Certificate of Appropriateness

Property	817-819 N. Marshall St.	Charles Koeffler Jr. House
Description of work	The house will be converted to a commercial boutique hotel and supporting cocktail lounge. General rehabilitation and maintenance will be performed. Exterior alterations include an attached rear deck connecting to an accessible entry in a bay window and a commercial kitchen hood on the rear.	
Date issued	7/26/2019	PTS ID 114772 COA: hotel conversion

Existing elevations

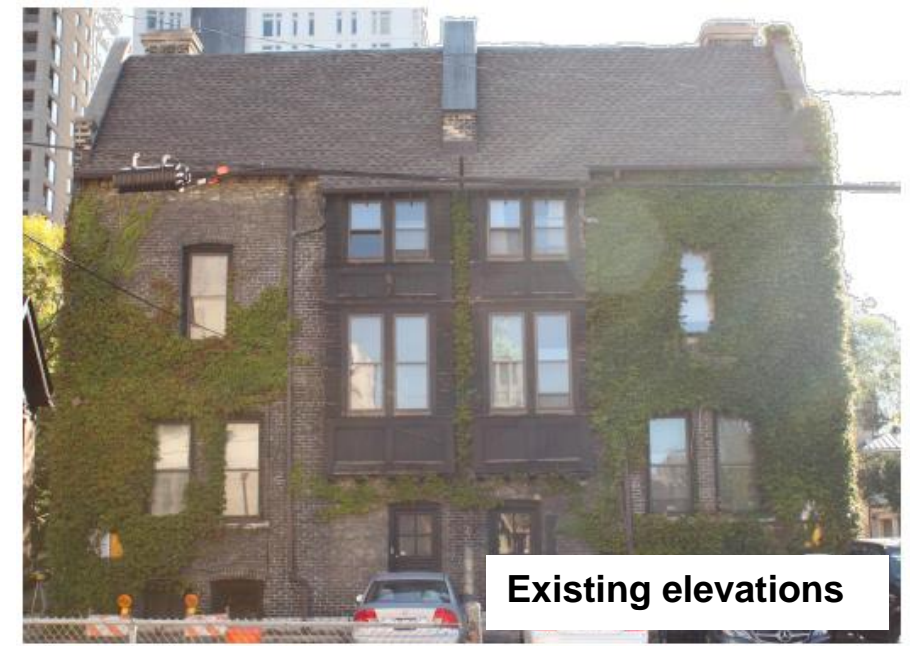
Work to be done on this elevation includes general rehab and maintenance of brick and stone (**masonry conditions apply**), paint existing wood windows, replace pipe handrail with iron rail, replace/repair existing porch tiles (**MUST match square/octagon pattern of tiles with new materials, masonry conditions apply**) and add new canopy sign above the entrance with ground placed spotlight (**details regarding the installation of the sign are REQUIRED – submit for separate review**)

Work to be done on this elevation includes painting the existing wood windows and trim, tuck-pointing brick and stone (**masonry conditions apply**), and minimal landscaping.

Work to be done on this elevation includes painting the existing wood windows and trim, tuckpointing brick and stone (**masonry conditions apply**), the conversion of an existing bay window into an accessible entrance (see partial section and detail drawings), and a new exhaust fan for a kitchen hood to be painted black to match the windows and trim.

Work to be done on this elevation includes painting the existing wood windows and trim, tuckpointing brick and stone (**masonry conditions apply**), and the conversion of an existing bay window into an accessible entrance (see partial section and detail drawings).
